**MONTGOMERY COUNTY HISTORIC PRESERVATION COMMISSION**  
**STAFF REPORT**

<b>Address:</b>	21 Quincy Street, Chevy Chase	<b>Meeting Date:</b>	1/27/2021
<b>Resource:</b>	Contributing Resource <b>Chevy Chase Village Historic District</b>	<b>Report Date:</b>	1/20/2021
<b>Applicant:</b>	Andrew and Jennifer Tulumello (Wouter Boer, Architect) (Nick Reis, Landscape Architect)	<b>Public Notice:</b>	1/13/2021
		<b>Tax Credit:</b>	N/A
<b>Review:</b>	HAWP	<b>Staff:</b>	Dan Bruechert
<b>Case No:</b>	938097	<b>Tax Credit:</b>	n/a
<b>PROPOSAL:</b>	Swimming Pool, Accessory Construction, Tree Removal, and Hardscape Alteration

*Fig. 1: 21 Quincy St. is building on the left side of a double lot.*

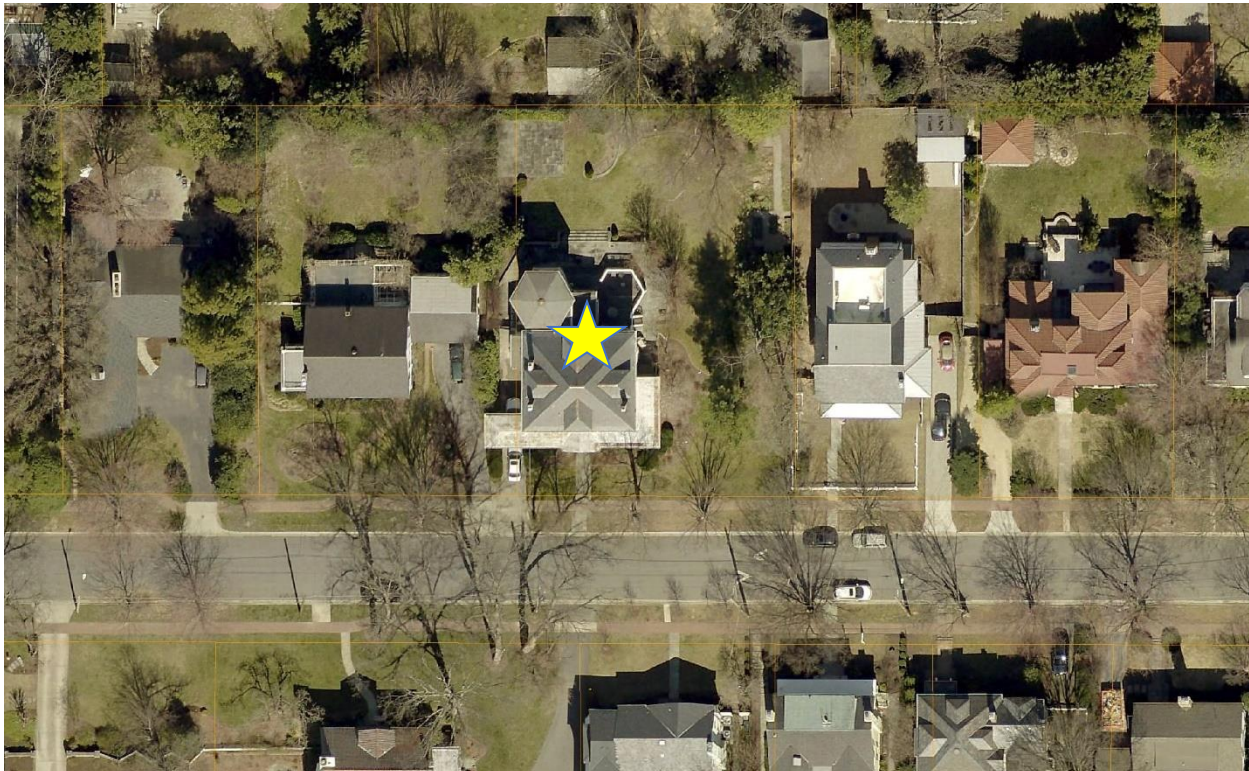
The large rectangular swimming pool measuring 15' × 45' (fifteen feet by forty-five feet) will be installed behind the house but will project into the side yard. The swimming pool will be installed at the required 15' (fifteen-foot) setback for swimming pools. Due to the rearward slope of the lot, the pool will be at least 4' (four feet) below grade at the sidewalk and, under the proposed hardscape plan, will be largely obscured by a retaining wall and only minimally visible from the public right-of-way. Under a *lenient scrutiny* review, Staff finds that the proposed swimming pool should be approved.

TULUMELLO POOL HOUSE • ELEVATIONS • JONES BOER ARCHITECTS

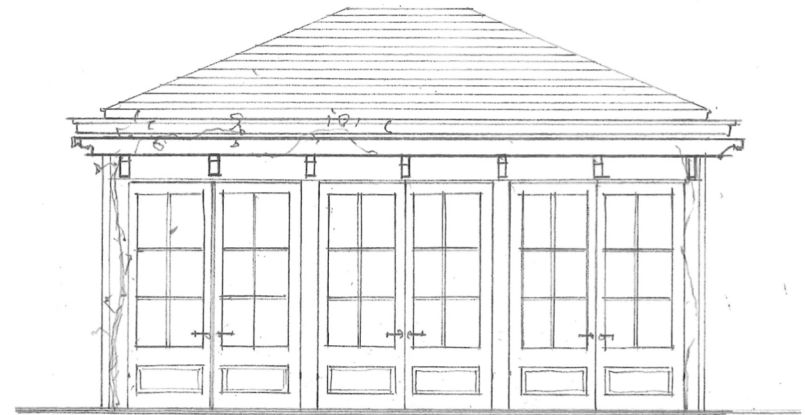
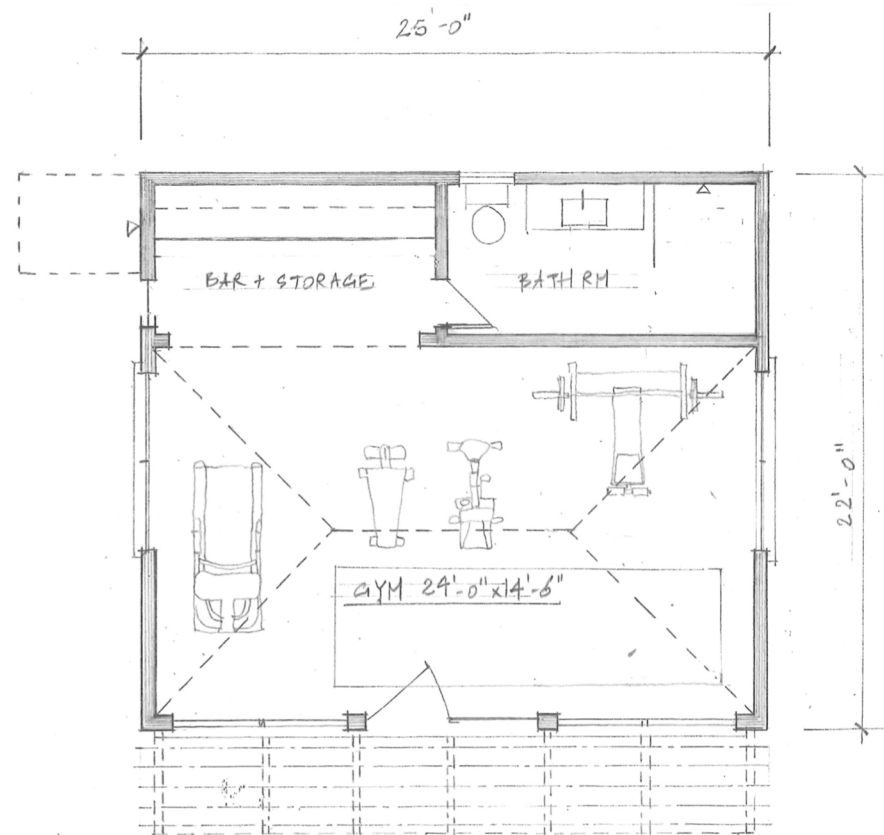
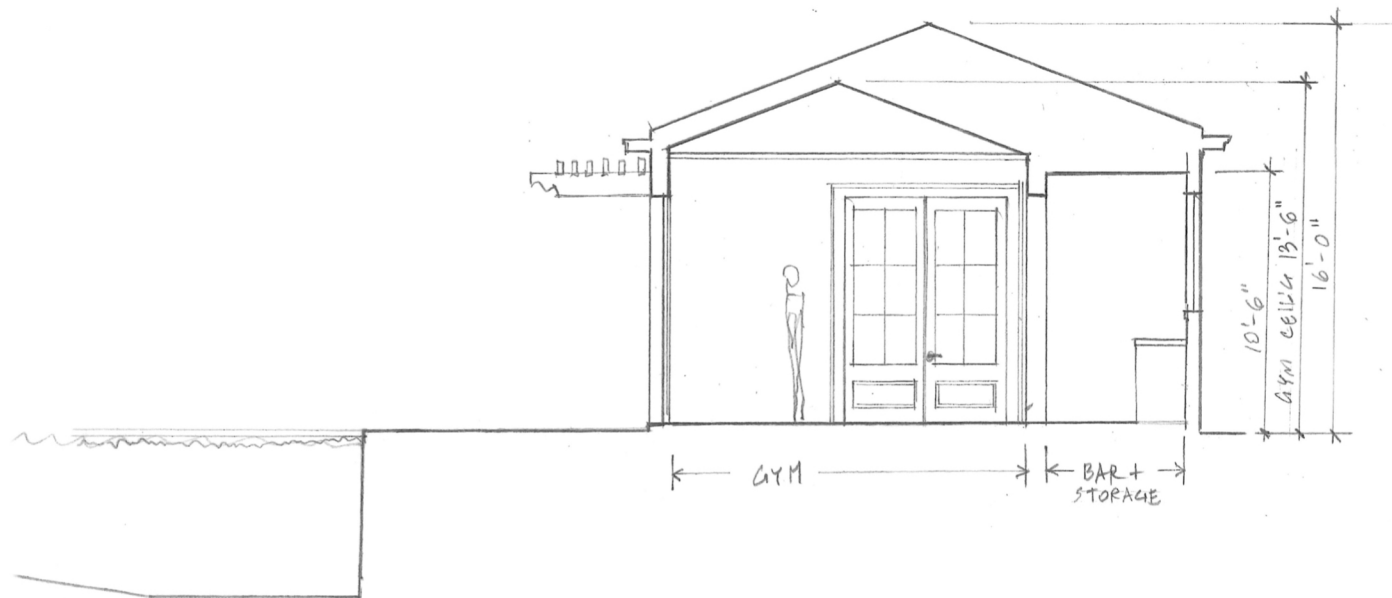
In the northeast corner of the lot, adjacent to the proposed swimming pool, the applicant proposes to construct an accessory structure that will be used as a pool house and gym. The rectangular structure will measure 25' × 22' (twenty-five feet by twenty-two feet) and will be 16' (sixteen feet) tall at the roof peak. Staff finds this size is consistent with a detached two-car garage. The proposed structure will be covered in wood siding to match the house, with several large windows. The north and south elevations will have a pair of French doors. The west elevation, which faces the swimming pool, will be a wall of windows. Above the west entrance, there is a proposed wood trellis.

The design discussed at the Preliminary Consultation included a flat roof. The Commissioners were split as to the appropriateness of a flat roof form and noted that green roofs frequently do not survive their first winter. The applicant eliminated this detail and went with a more traditional pyramidal roof.

As a detached accessory structure, the proposal should be reviewed under *lenient scrutiny*. The drop in grade on the site will reduce the visual impact of the proposed structure. Staff finds that the proposed size - that of a two-car garage - is not out of character with the house, the lot, or the surrounding district. Staff also finds the wood clapboard siding and asphalt shingle roof are consistent with the historic house and are compatible materials. Staff additionally finds the multi-lite window and door configuration to be appropriate for the design of the house with its six-over-one windows throughout.

# LG100

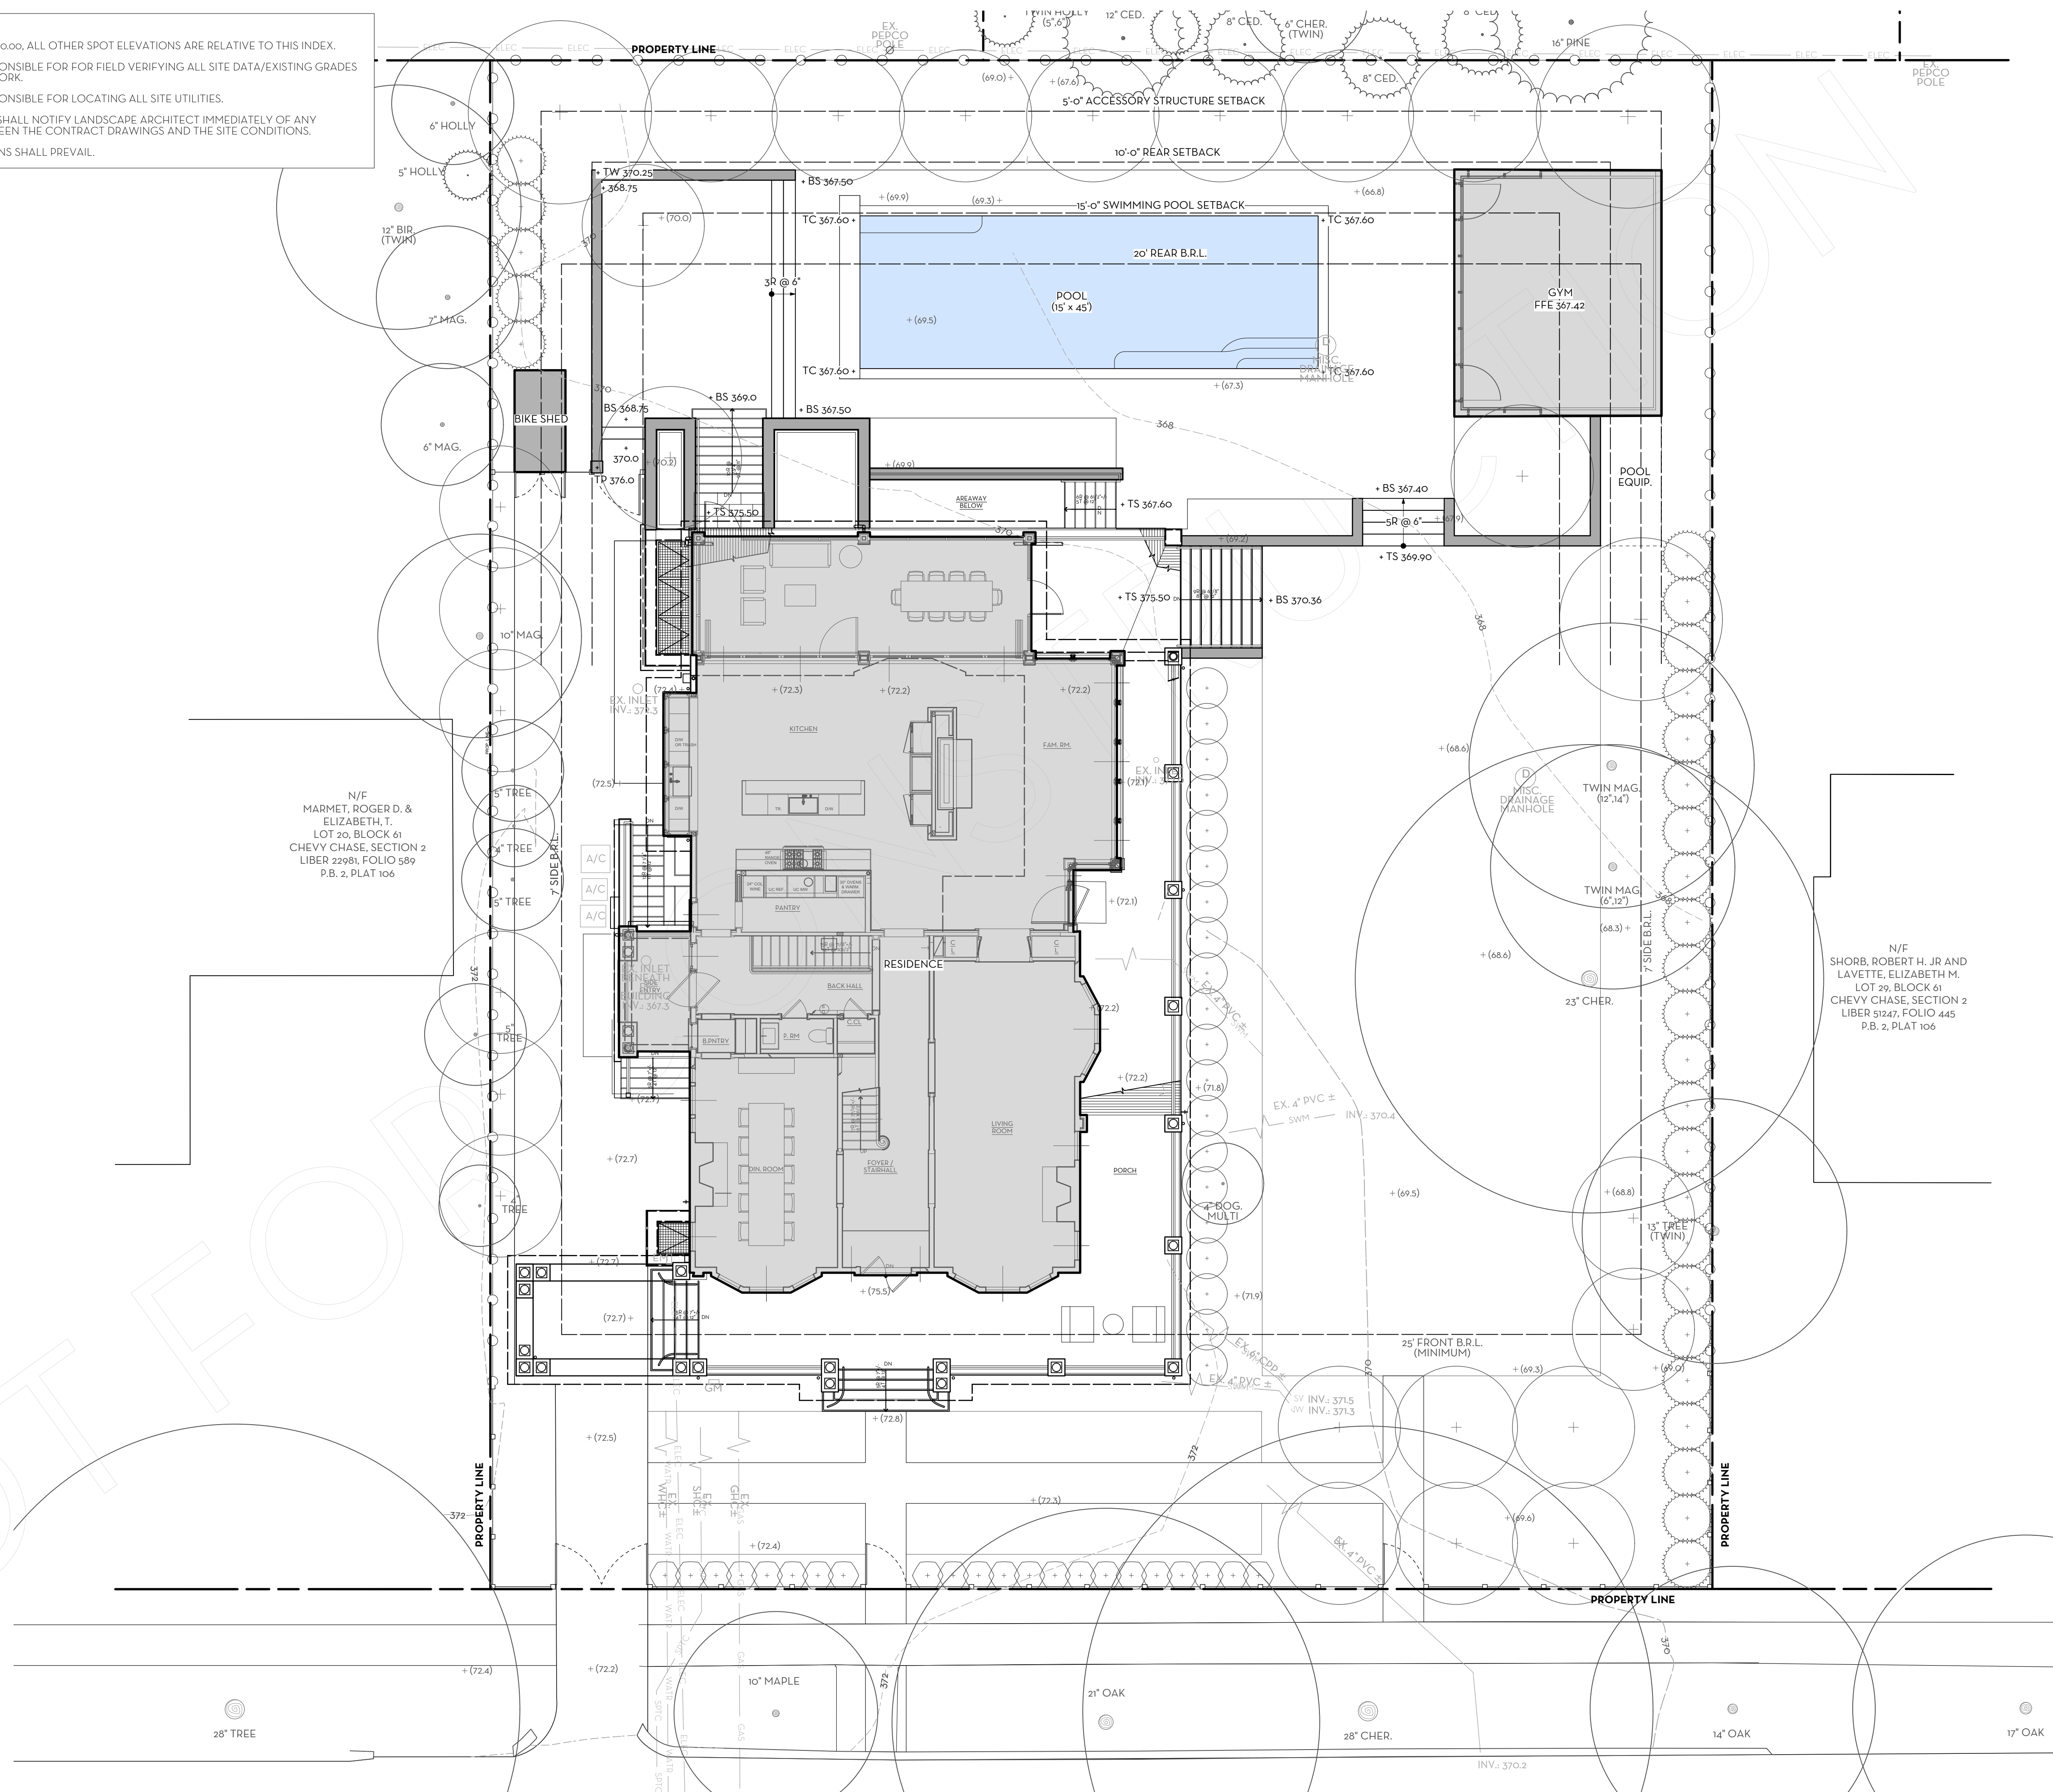
At the rear of the lot, surrounding the swimming pool, the applicant proposes to introduce pool decking, additional patio space, and retaining walls constructed to match the foundation stonework. The patio will be bluestone. In order to construct the proposed hardscaping, the applicant proposes to remove three birch trees (several other trees are proposed for removal, however, they are smaller than the 6" d.b.h. threshold requiring a HAWP).

Staff finds that the amount of proposed hardscaping is significant. But because of the size and number of the integrated planters, Staff does not find the amount of hardscaping negatively impacts the "open, park-like character" of the district to a degree that it shouldn't be supported. The HPC was generally uniform in agreeing with Staff's assertion that the proposal would retain the open park-like setting with the additional paving at the rear. As this work is at the rear of the lot and below street grade, it will have less impact on the surrounding streetscape than a proposal to pave over the front or side yard.

In addition to the birch trees, mentioned above, the applicant proposes to remove a 21" (twenty-one inch) pine tree in the side lot. This is a substantial tree that projects into the largely-open side yard. The applicant proposes planting 25 (twenty-five) trees on the lot to mitigate the loss of trees and as part of the landscape plan for the site. Staff finds that the loss of the pine tree will not have a significant impact on the site or surrounding district, particularly because of its proximity to a 23" (twenty-three inch) cherry tree. Additionally, the new trees will be largely native species that will fill out the tree canopy on the site and contribute to the district's open, park-like setting. Staff recommends the HPC approve the tree removal and replacement.
